To:	Teri Camery (CBJ)	Date:	April 27, 2022
c:	Scott Ciambor (CBJ)	Memo No.:	3
From:	Rita Kors-Olthof, Vladislav Roujanski, Shirley McCuaig	File:	704-ENG.EARC03168-01 / 704-ENG.EARC0168-02A
Subject:	Mapping Overview at Starr Hill Subdivision and Additional Information Downtown Juneau Landslide and Avalanche Hazard Assessment

2.1 Mapping Overview at Starr Hill Subdivision

Figure 2: Excerpts from Swanston (1972) – Figure 5 – Historic Landslide Deposits (Figure 2A) and Figure 6 – Mass Wasting Hazard Areas (Figure 2B).

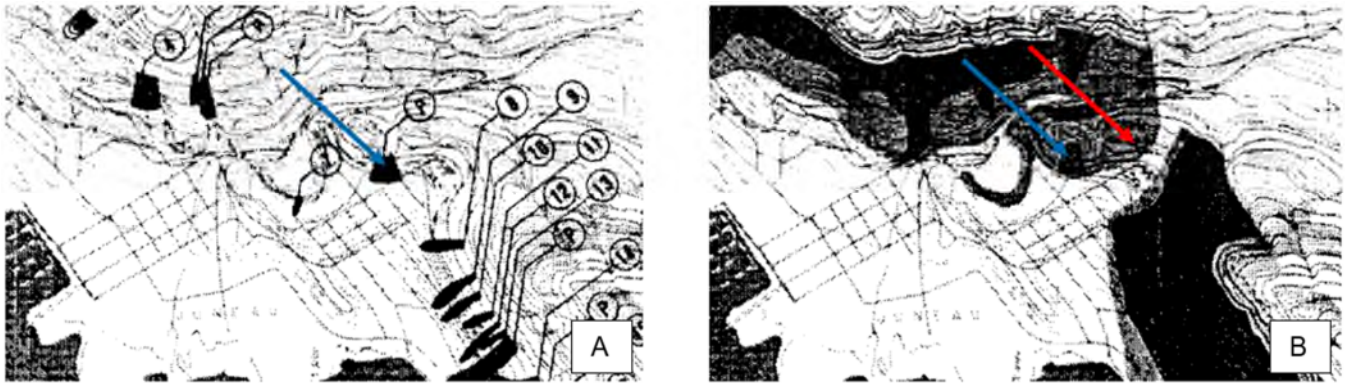
In Swanston’s Figure 5, “P” means “Prehistoric” (before 1880). A prehistoric slide area was noted on the south side of Mt. Maria (blue arrow in Figure 2A). In Swanston’s Figure 6 (Figure 2B), hazards for mass wasting (landslide) hazard areas are shown, with *Potential* Hazards marked in gray, and *High* Hazards marked in black. The prehistoric slide is shown as a *High* Hazard area (blue arrow in Figure 2B). A small cliff with a talus deposit above the corner of 6th and Nelson Streets was also designated as being in a *High* Hazard area (red arrow in Figure 2B).

Comparing Swanston’s hazard mapping (Figure 2B) with the 1987 adopted mapping (Figure 1A), CBJ renamed Swanston’s “*Potential* Hazard” as *Moderate* Hazard and renamed Swanston’s “*High* Hazard” as *Severe* Hazard.

Figure 3: Excerpts from Tetra Tech Figure 1.3b Surficial Geology (Figure 3A), and Figures 1.6c and 1.6h Landslide Hazard Designation Mapping (Figure 3B).

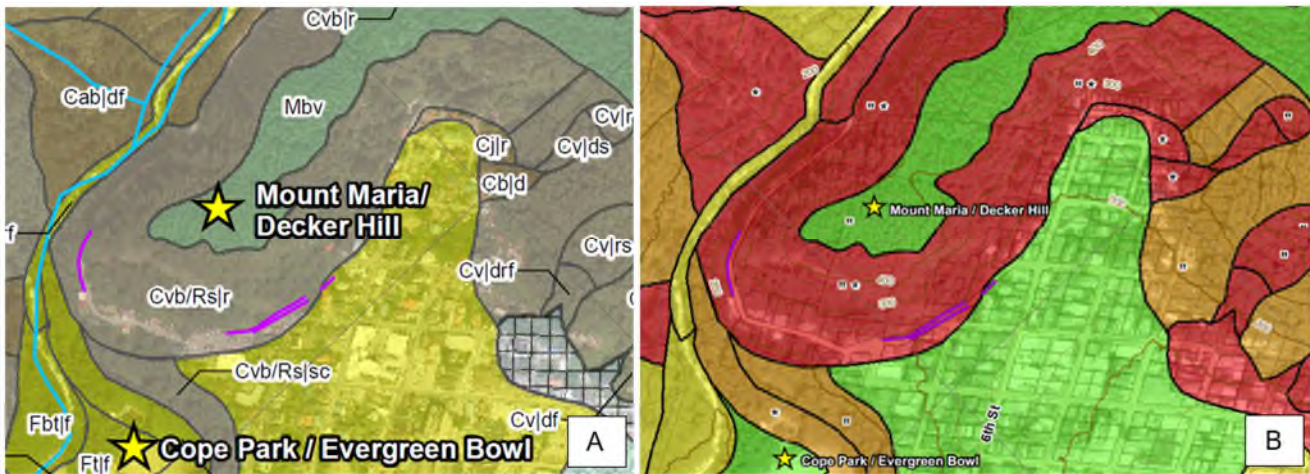
A summary of Tetra Tech’s mapping of the Starr Hill area and the adjacent portion of Basin Road is shown below in Figure 3, with surficial geology in Figure 3A and landslide hazard designation mapping in Figure 3B. There is a clear correlation between the shapes of the surficial geology units and the associated landslide hazard designations.

Severe hazard designations are assigned to the areas subject to rockfall, debris slides, and debris flows, as shown on the surficial geology map in Figure 3A. Areas with a *High* hazard rating were assigned based on the results of the semi-quantitative analysis. These areas are expected to experience rockfall that damages but does not always knock out trees, and as such are a less severe hazard than a debris flow or debris slide that removes everything in its path. Evidence of this type of rockfall activity was identified during the field investigation.

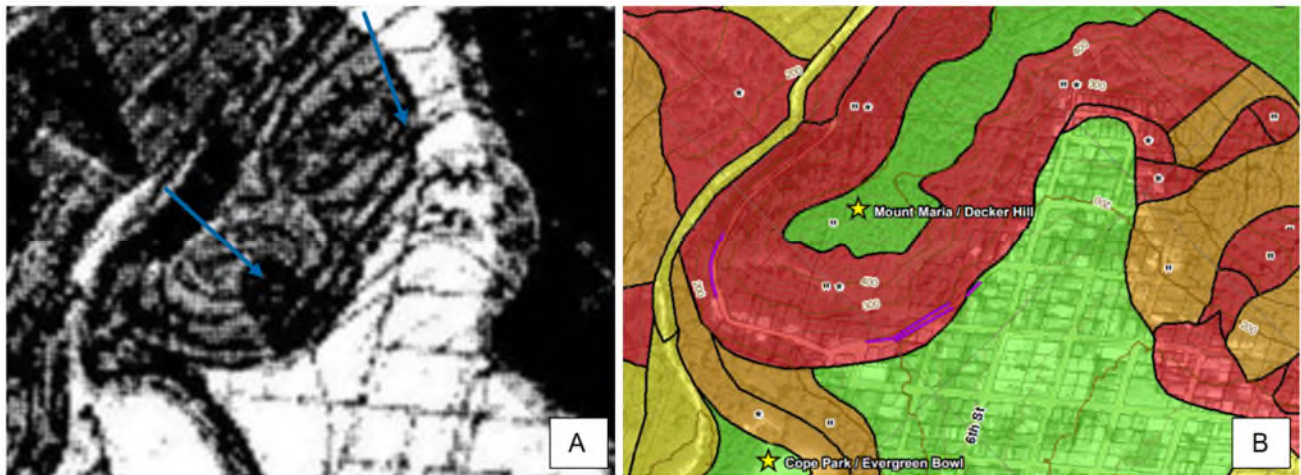
Some parallels can be seen in the locations of the mapping boundaries of Swanston (1972) and Tetra Tech (2021), in that they appear to follow the terrain (in contrast to the 1987 mapping which defers to nearby property lines). However, there are some significant differences in the details, due to better quality data, i.e., higher resolution imagery and new LiDAR data available to Tetra Tech, and more advanced mapping techniques used in the current study (Figure 4).

As shown in Figure 4A, Swanston mapped most of Mt. Maria on the Starr Hill side as having a *Potential Hazard* (gray area), except at the prehistoric slide area and a small cliff above the corner of 6th and Nelson Streets, which were designated as being in *High Hazard* areas (blue arrows). These two areas are also shown with blue arrows in Figure 5. Heading northeast along 6th Street from Basin Road towards Nelson Street, the lower boundary of Swanston’s *Potential Hazard* area was mapped progressively closer to 6th Street.

Along the entire southeast edge of Starr Hill, including a portion of the mapped lots, Swanston (1972) marked an area of *Potential Hazard*, with *High Hazard* marked further upslope on Mt. Roberts. The lower boundary of Swanston’s *Potential Hazard* area begins at about Harris and 4th Streets, becoming progressively closer to 5th Street heading northeast. The northeast corner of Swanston’s mapped landslide hazard area curves to the north to encompass the terrain southeast and northeast, upslope of the corner of Nelson and 5th Streets. Swanston did not designate hazards along or above the northwest part of Nelson Street. CBJ’s 1987 adopted map called that area *Moderate* (Figure 1A).

Figure 5: Excerpt from Swanston (1972) Figure 7 – “Mass Wasting Channels and Rock Slide Areas.” Striped map areas are rockslide hazard areas; heavy numbered lines are mass movement channels.

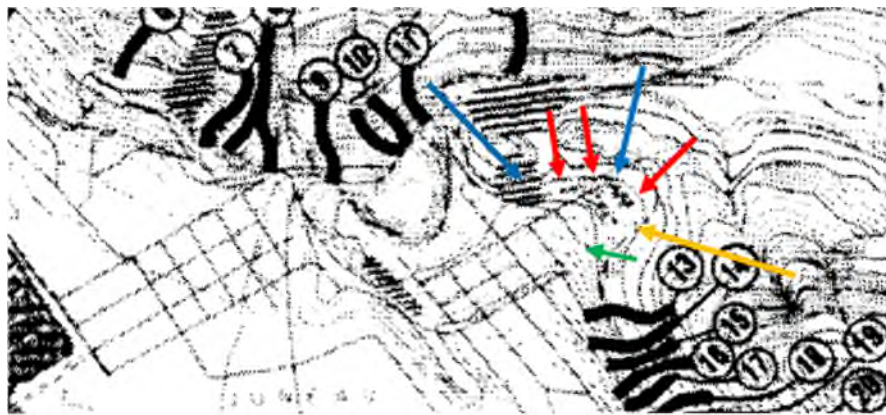
Swanston’s mapped rockslide hazard appears to continue around the corner to Nelson Street (more red arrows in Figure 5), although that is less clear due to the poor scan quality of Swanston’s mapping. The presence of rockfall/rockslide hazard areas along Nelson Street did not appear to be reflected in Swanston’s hazard mapping (Figure 4A).

On the southeast side of the subdivision, Swanston (1972) also found a record of a “slump” that occurred on November 27, 1935, at “5th Street above Kennedy” Street that did not cause damage. Swanston did not map that feature; however, nor did he detail the active slope processes at that location. The debris flow feature identified by Tetra Tech between Kennedy and Park Streets and upslope (southeast) of 5th Street, might be related to the “slump” mentioned by Swanston (located at approximately the orange arrow on Figure 5). That significant debris flow gully (called G000 Park in the new avalanche mapping) appears to be a different debris flow than the feature identified by Miller (1975), which is located slightly to the southwest, between East and Kennedy Streets (green arrow on Figure 5).

At that location, Miller (1975) showed a debris flow about 85 yards long that he reported as a 1972 event. Due to this location being located at the edge of one of the air photos, and possibly due to regrowth of vegetation since 1972, Tetra Tech’s review of the 1977 air photos was inconclusive. However, Google Street View (July 2011 imagery), near the southeast end of the paved part of East Street, clearly shows the aftermath of a recent debris flow and/or erosion type event from upslope of the road at 415 East Street. The 2013 imagery also suggests disturbed ground between the house closest to the road and the next house located almost due east at 622 4th Street.

The prehistoric slide area (Figure 5, blue arrow on left side) appears to be in the same place where a rockfall/rockslide was reported on October 18, 1913 (Swanston 1972, Figure 6), and where a distinct landslide scar is still present despite reforestation of the slope (Figure 13). Swanston reported that several houses had been destroyed, and that a deposit of angular rock fragments had been created above Basin Road between 6th and 7th Streets.

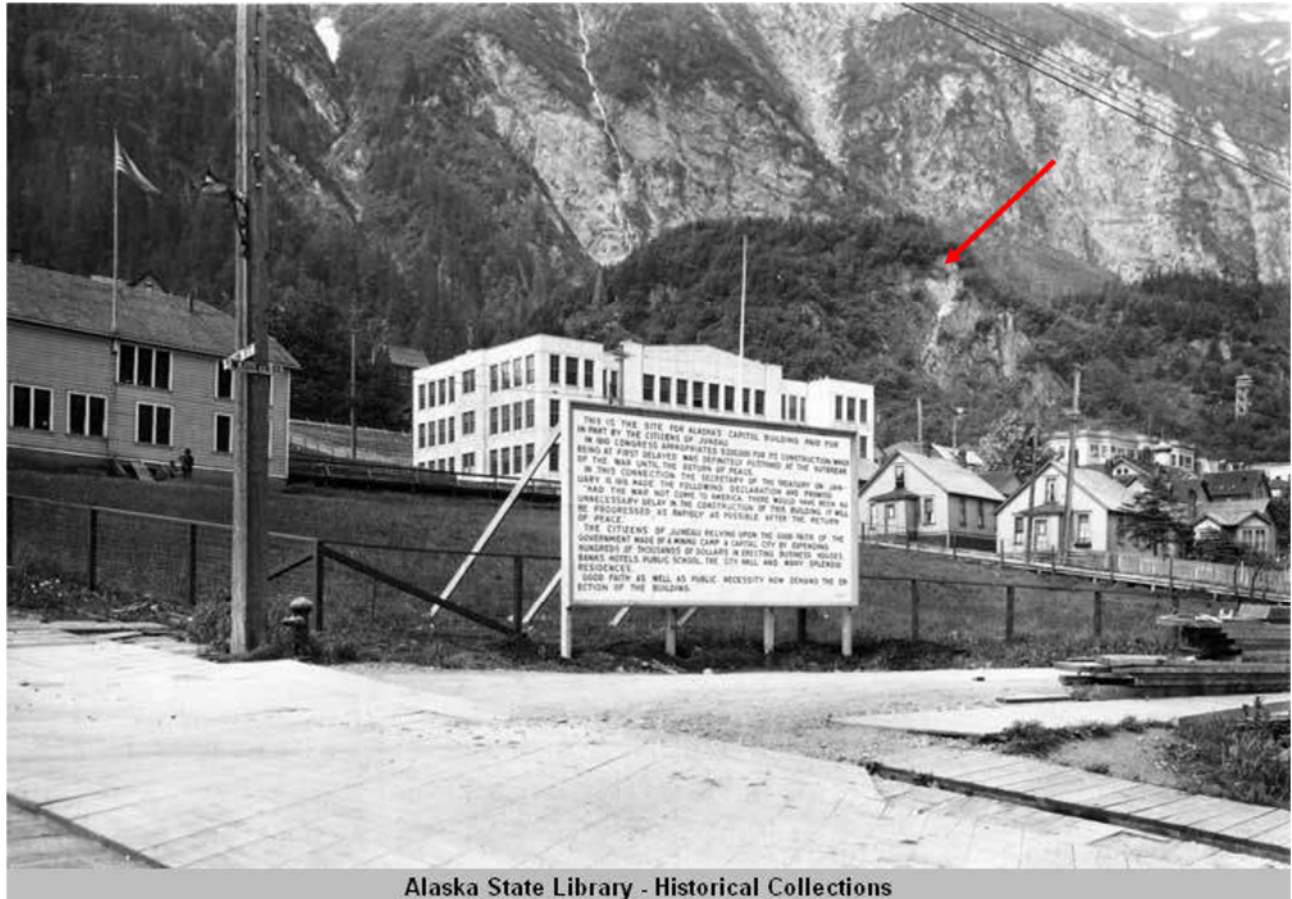
1. **Question/Comment:** I've seen the rockfall above Basin Road, and I can see why that slope is in a *Severe* hazard zone, but what about the slope above 6th Street? Why is that *Severe*?

A news story about the 1913 event reported two large rocks, each several tons in weight, falling from the cliff on the side of Decker Hill facing town and above Basin Road (Figure 6). One of these rocks impacted a huge boulder below, which had lain there for many years and, although the falling rock lifted the existing boulder up on edge, it was prevented from travelling further downslope. That existing boulder was reported to be located at the edge of the road, opposite the Nelson home, protecting it. The other large rock that fell was deflected and crossed the road to crush a woodshed below Basin Road, at the Price home. The power poles along Basin Road were also snapped, resulting in a short circuit (The Alaska Daily Empire October 20, 1913). The Nelson

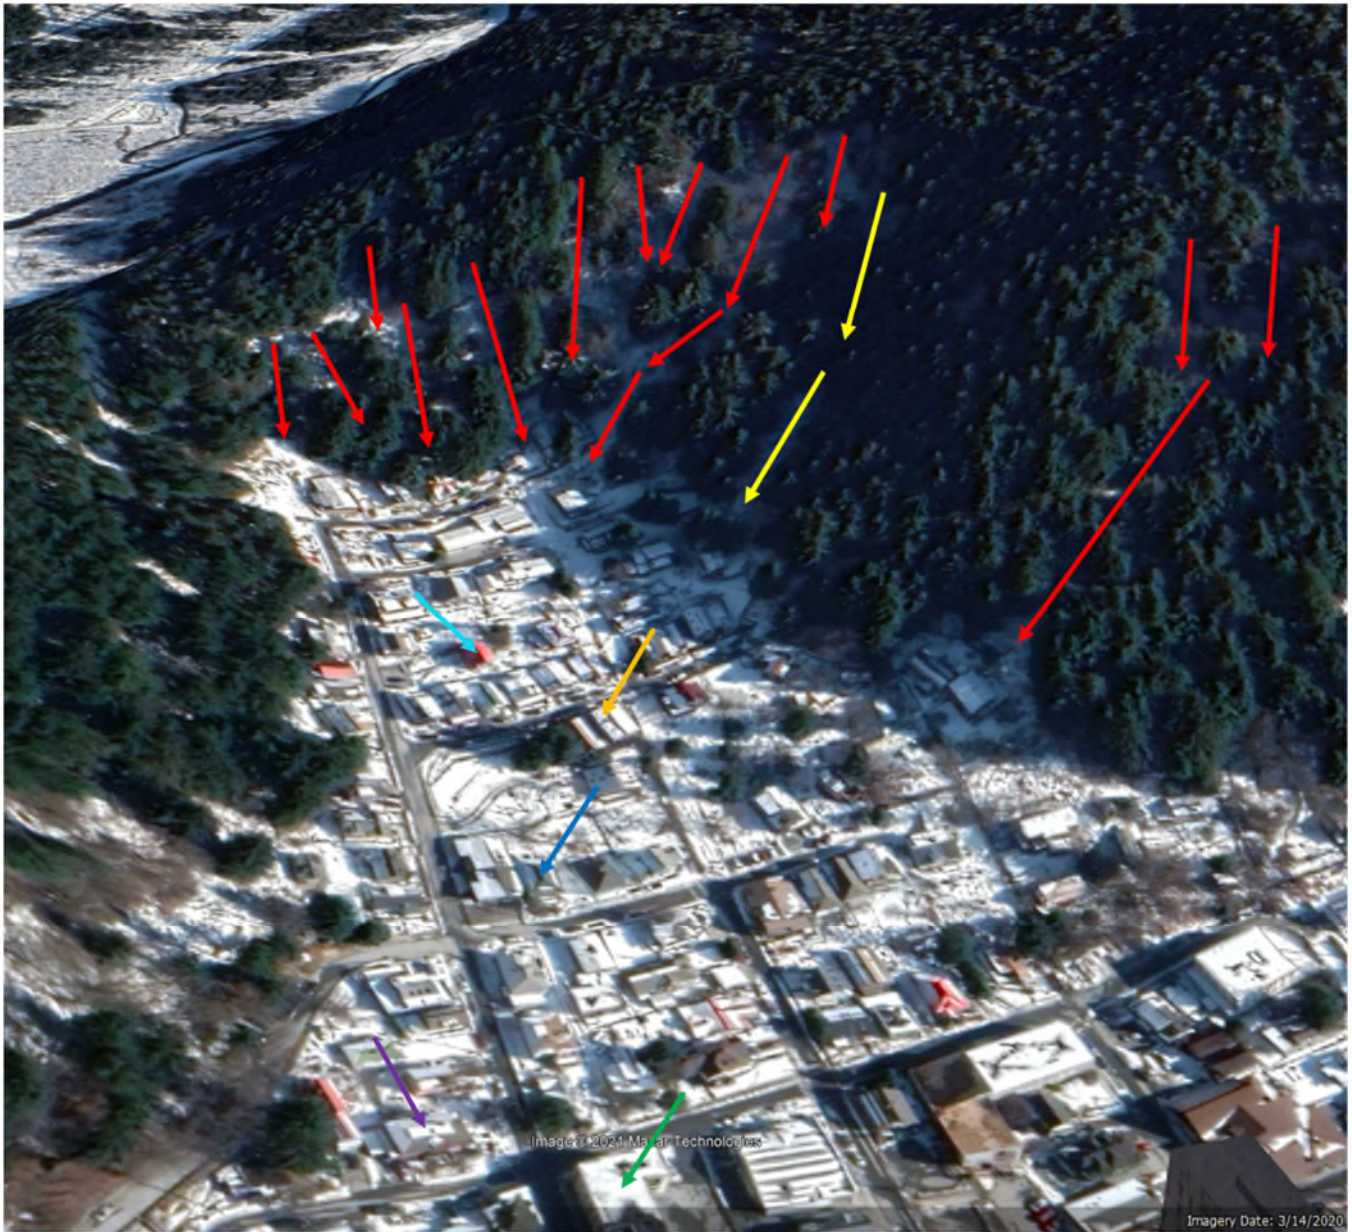
5. **Question/Comment:** We question the high risk [orange] designation adjacent to the gully, as the topography is relatively dry, stable, and does not seem to foster conditions for any landslide, debris flow, or erosion.

In Figure 12, one of the main gullies (shown with two bright yellow arrows, ending between Park and Kennedy Streets) is the G000 Park debris flow gully. See Figure 15 for more information about this gully.

Answer: The answer to this question can be applied to both areas mapped as *High* hazard terrain (orange) beside the G000 Park gully: the open slopes located to the southwest and northeast of the debris flow gully. The bowl-shaped terrain located upslope of the corner of Nelson and 5th Streets is now mapped as *Severe*, so this discussion no longer applies to that terrain (see Question #2). The surficial geology is the same in both areas. The review of the slopes in Question #3 provides some useful background in the slope processes that are happening in this area of Starr Hill. Figure 15 shows clearly the very rough and disturbed terrain that has resulted from highly active slope processes, particularly on the northeast side of the G000 Park gully. Figures 10, 11, and 12 show the paths along which the most frequent landslides (debris slides/flows) tend to occur northeast of the gully, and Figure 12 also shows the paths southwest of the gully.

On the right-hand side of Figure 12, for the area southwest of the G000 Park gully, there are two red arrows high on the slope and a longer red arrow on the lower slope. The two upper red arrows on Figure 12 show the main areas of slope instability activity higher on the slope and, as seen on Figure 15, this instability is related to the rock bluffs/cliffs upslope, resulting in rockfall/rockslides. The geology mapping shows that debris slides can occur in this terrain too. The lower longer arrow indicates a transition zone where most of the rockslide or debris slide material continues downslope. Due to the open-slope environment, this slope is not as hazardous as the debris flow gullies on either side. However, the prominent toe of slope at the edge of the residential area clearly shows the edge of this terrain unit, and the considerable proportion of ground with sparse or no tree cover upslope is indicative of ongoing slope instabilities. This is why this slope section has a *High* hazard designation.

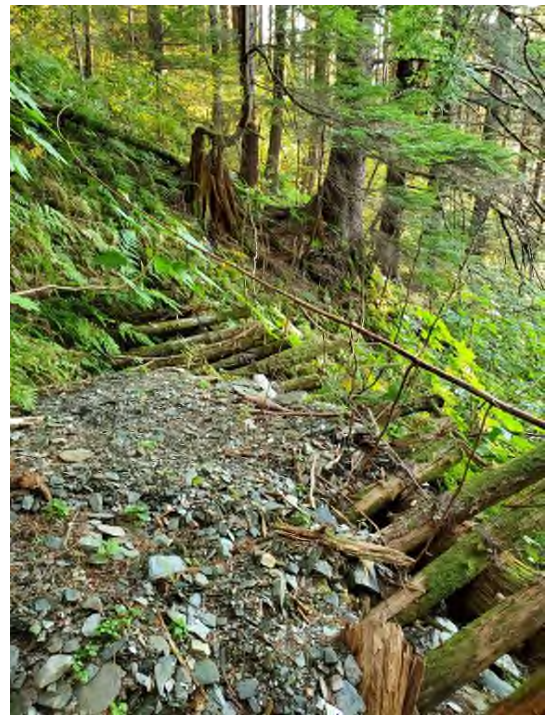
4. **Question/Comment:** We agree that there is landslide activity in the [G000] Park gully, but properties have largely been protected by maintenance and instream mitigation structures and drains. The structures were installed by homeowners... with materials that were supplied by the City and Borough of Juneau. Some of these structures need to be repaired or replaced in order to continue proper drainage of this creek through the city-installed culvert that runs under the 725 5th Street home.

The area designated as *Severe* (red) has resulted in two debris flow events in the last 35 years... A debris flow incident occurred in the late 1980s, as a result of the drain above 725 5th Street becoming plugged because the home was vacant and there was no one to monitor/maintain the drain. In 2019, the gully creek undercut a bank, causing a flowerpot to fall and temporarily block the flow.

Although the residents have reported only two debris flow events in the past 35 years, this does not mean that the hazard is not significant. Based on the field observations, this debris flow gully has a high potential to affect downslope residences. Clearly, residents were concerned enough about the debris flow hazard to build structures to control debris flows, but these structures are not by any means engineered structures (Figure 16). Routing a debris-flow creek under a house also seems fraught, considering that the drain upslope has become plugged in the past, and that the slightest misstep upslope can create further havoc. (Case in point, the creek undercutting the stream bank and a fallen flowerpot blocking the flow in 2019.) Furthermore, as shown in Figure 15, it appears that this debris flow gully could potentially receive significantly more debris and water than just from the local slopes. As it stands, due to these multiple sources of hazard, Tetra Tech considers that this debris flow gully has been correctly designated as *Severe*.

Depending on the size of the next debris flow, the structure shown in Figure 16 could retain a little more debris or, instead, it could collapse, be overrun by debris, or even be completely scoured out by a larger debris flow that could originate from further up the gully. The same applies to the other structures documented by residents. Debris can incorporate both large and small woody debris, as seen in these photos and the photos supplied by residents of the mid and upper reaches of the gully. The upslope portion of this debris flow feature is bowl-shaped, indicating the potential for small debris slides from the side slopes to fail and entrain debris in the gully, of which there is a significant amount. The particle size of the material that can be moved by a debris flow is

also important – some cobble- and boulder-sized material is also visible in the residents' photos. Despite the mitigation attempts, debris slides/flows could result in enough volume to impact the houses below.

Figure 18: Excerpt from the landslide hazard designation mapping. The purple outline shows an area where residents requested more information to understand the shapes of the mapping units and the reasons supporting the hazard designations.

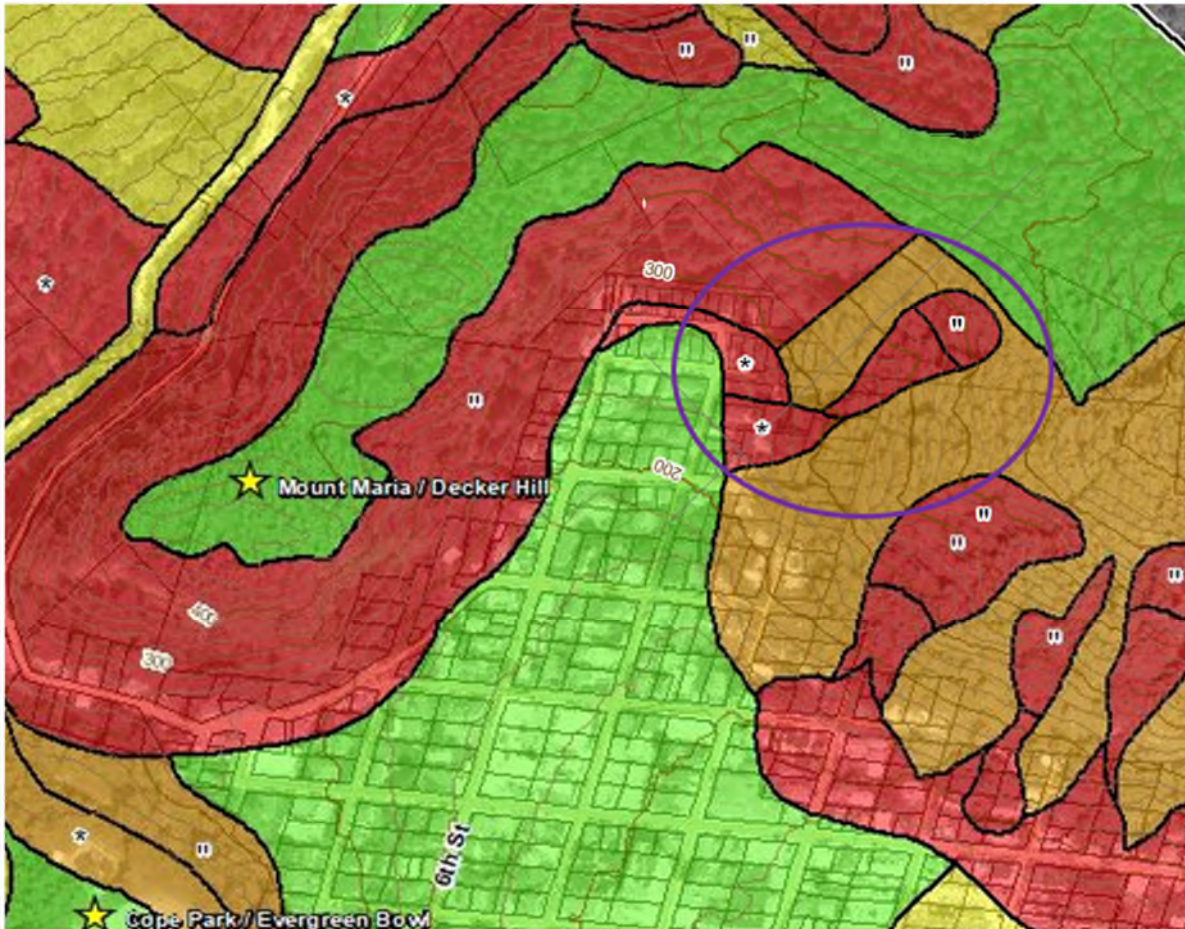
6. **Question/Comment:** The boundaries between the *Low*, *Moderate*, *High*, and *Severe* landslide hazard zones do not seem to match the land.

Answer: The boundaries between the different landslide hazard designation zones are closely related to the surficial geology mapping terrain unit boundaries (Figure 3A). The reason for this relationship is that the different soil and rock features have a large influence on how the slopes behave. For shapes that do not seem to make sense, it is helpful to look at the features beside that odd shape. Usually, it will be a terrain feature whose characteristics will govern the shape of the boundary between the two units, like a bedrock outcrop, or a terrain unit that overlaps a previous unit. Sometimes, the odd-looking boundary is only because there is a corner or curve in the slope, so that debris from one side falls down in one direction, and material from the other side falls down in a different direction. These two debris areas might then meet at the bottom of the slope, like the southeast corner of Starr Hill, where debris can fall or slide from above Nelson Street, and it can also fall or slide or flow from above 5th Street. Since this part of the subdivision is essentially the shape of a bowl, the mapping of the unit boundaries can also reflect slope contours and fall-lines, as well as the surficial geology unit boundaries. See also Technical Memo #2, Question #3, for more explanation on how apparently odd-shaped boundaries are determined.

Specific to this area of Starr Hill, it is now known that a resident has identified a recent landslide event in a *High* hazard zone (see Question #6 above), which also happened to be within one of the apparently odd-shaped hazard units (Figure 18, purple outline). This area has now been updated, resulted in a shifting of the hazard boundary above the corner of Nelson Street and 5th Street. Note that the *Severe* hazard zone mapped at the toe of slope is due to this area being a deposition zone for slide debris.
